PROJECT REVIEW REPORT

Project ID	1141
Project Name	Fresh Breeze Afforestation Project
Review Type	Verification Requested
Program(s)	VCS Program
Verification Period	1 st January 2021 to 31 st October 2022
Project Proponent	PROTEAK UNO S.A.B. de C.V.
Methodology	AR-ACM0003 – Afforestation and reforestation of lands except wetlands, v01
VVB	AENOR CONFIA S.A.U.
Assessment Criteria	VCS Standard v4.5
Date of First Issue	16 September 2024
Date of Second Issue	31 January 2025
Date of Third Issue	07 April 2025
Review Conclusion	Closed
Date of Final Issue	02 July 2025

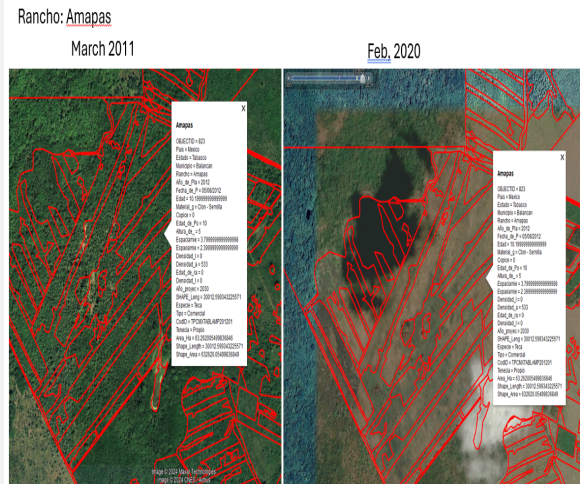
Plantation year mentioned as 2012, however, image shows no plantation in year 2020. In 2011 the area shows natural vegetation cover.

4. Image from Google Earth show difference in the plantation year and actual plantation

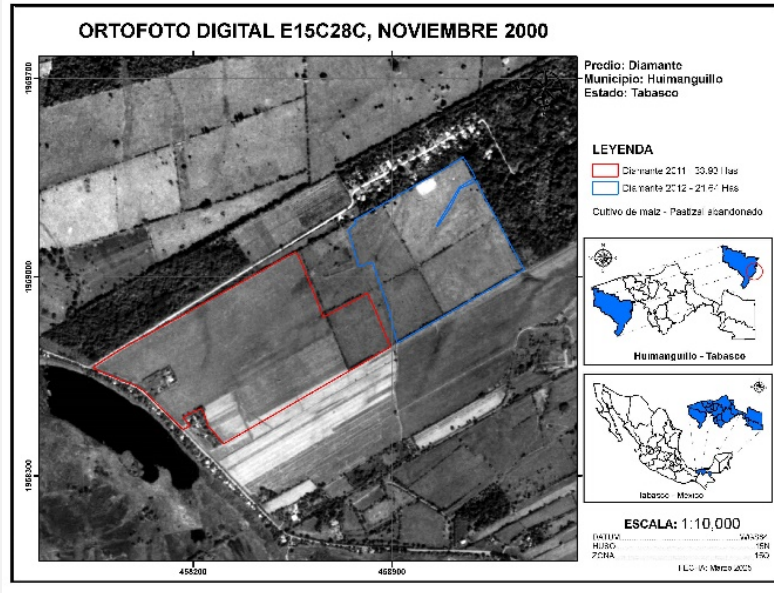
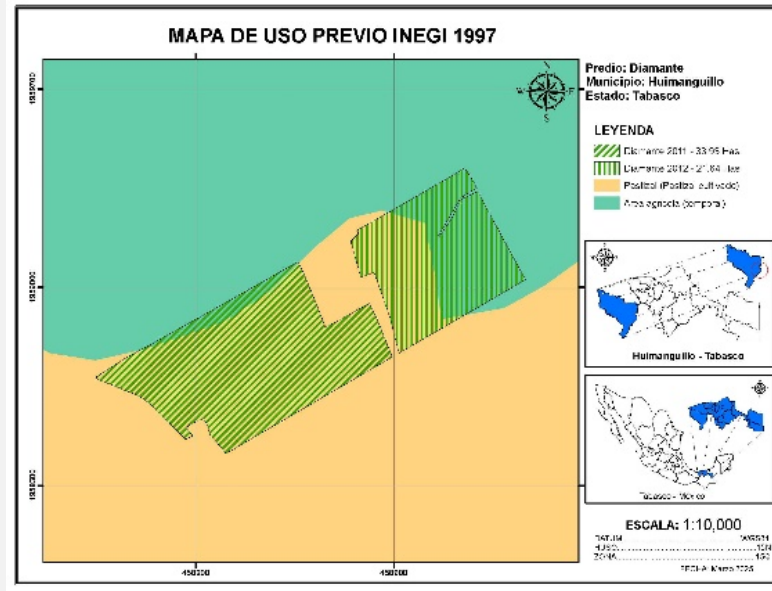
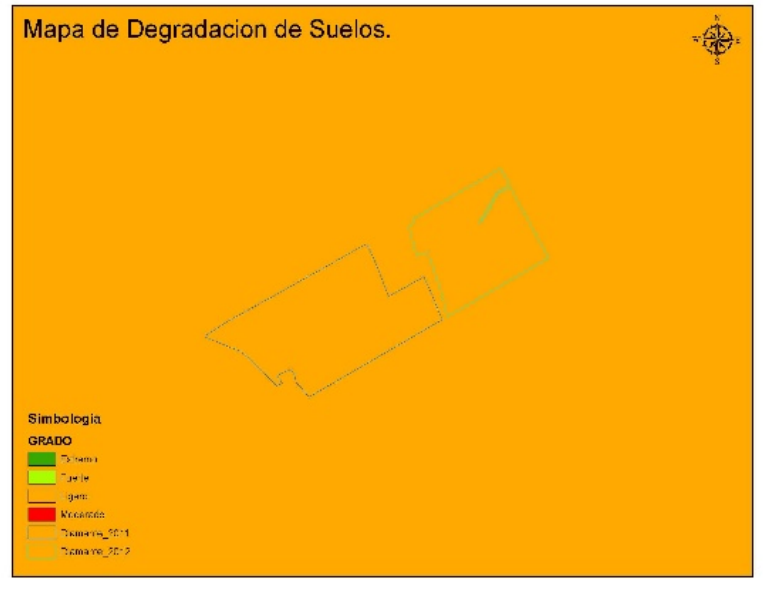
<p><u>Verra Response</u></p> <p>An explanation has been provided. However, this finding cannot be closed.</p> <p><u>Issue</u></p> <ol style="list-style-type: none"> 1. It remains unclear why the baseline emissions do not account for the vegetation clearing that occurred in the project area polygons, such as the Diamante farm. 2. It remains unclear how the cleared areas, such as the Diamante farm, correspond to the degraded grassland baseline specified in

<p>the validated PD.</p> <p><u>Action required.</u></p> <ol style="list-style-type: none"> 1. The VVB must ensure that the baseline emissions are revised to account for the vegetation clearing that occurred in certain project area polygons, such as the Diamante farm. 2. The VVB must ensure that the project clarifies how the cleared areas, such as the Diamante farm, correspond to the degraded grassland baseline specified in the validated PD, or exclude them. 	
		<p>Round 3</p>	
		<p><u>VVB Response:</u></p> <p>Response to action required 1:</p> <p>According to the PD validated, Section 3.2.3: "For Shrubs consideration, the tool: Estimation of carbon stocks and change in carbon stocks of trees and shrubs in A/R CDM project activities, is applied. The PPs determined data of shrub crown cover by means of photo and management plans and demonstrated that data is less than 5 per cent in areas under the project boundary, then, the shrub biomass per hectare is considered negligible and hence accounts as zero. As complement the photo of each plantation demonstrate that the shrub is not predominant before the project implementation, therefore the carbon stock of shrub in the baseline is neglected."</p> <p>Due to the above, in the current MR, a deviation was requested to be able to use better information than mere ocular field observation; In this regard, the following was presented:</p> <p>Land use assessment for each farm, using any of the following information: Previous Use INEGI 1997 and/or Orthophoto 1996 and/or Orthophoto 2000 and/or Orthophoto 2001 and/or Orthophoto 2005. As documented (previous land use, at least 10 years prior), almost all areas were grasslands (in some cases, abandoned), and in some portions, were agricultural crops (See Evidence Summary of Historical Land Use.xlsx); the evidence presented (- Map for each property, using</p>

The first teak plantation on this farm was established in 2011; the assessment of the previous land use and existing vegetation is since 2000, less than 11 years, but more than 10. Given this, the evidence is in compliance with the eligibility criteria.

In addition, with the new information presented for every farm, the previous land use in 1997 (at least 14 year before the start of project activities) was conclusive as pasture, with some small areas used for agricultural production; with this evidence, the instance, complies with the eligibility criteria.

The last assessment regarding previous land use and baseline emissions, is related to degradation of land; According to the national information of Mexico, the Project area in this instance, was categorized as degraded.

All the previous evidence (3 different assessments) was generated with the best specific information for the project; national and official to Mexico. It demonstrates that no vegetation clearing occurred within project area polygons.

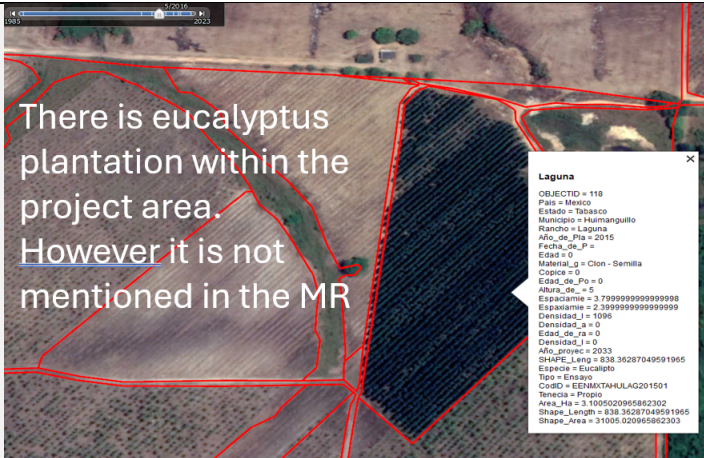
Additionally, there is a patch where the attributes indicate that Teak has been planted. However, the plantation pattern in this specific area appears significantly different. Based on its spatial characteristics, the patch seems to contain a different species, potentially palm, suggesting a discrepancy between the documented species and the observed pattern.

Issue
It is unclear how the emissions associated with the elimination or replacement of trees from the 2015 Laguna and 2016 San Pablo plantations have been included in the ERR calculations.

1. The VVB must ensure that the project clarifies how the emissions associated with the elimination or replacement of trees from the 2015 Laguna and 2016 San Pablo plantations have been included in the ERR calculations. This clarification should be clearly reflected in the ERR calculation spreadsheet.
2. The VVB must assess the revised MR and ERR calculation spreadsheet and update the VR as necessary.

VVB Response:
Action 1. The PP, in the new version of the MR (section 5.2), explains how the two new substrates included in this report were generated (La Laguna 2015 and San Pablo 2016); it also explains how the emissions generated by the elimination of portions of the plantations in 2012 (La Laguna) and 2010 (San Pablo), respectively, led to the elimination of the existing biomass, and how the emissions caused by this adaptive action are discounted, corresponding to a total of 10,159.04 tons CO2 -e.
New evidence presented:
- New version of the ERR spreadsheet: PT-FB-MR2022 measurement and calculation v4.xlsx
- New version of the MR: PT-FB-Monitoring Report 2022 v5.docx
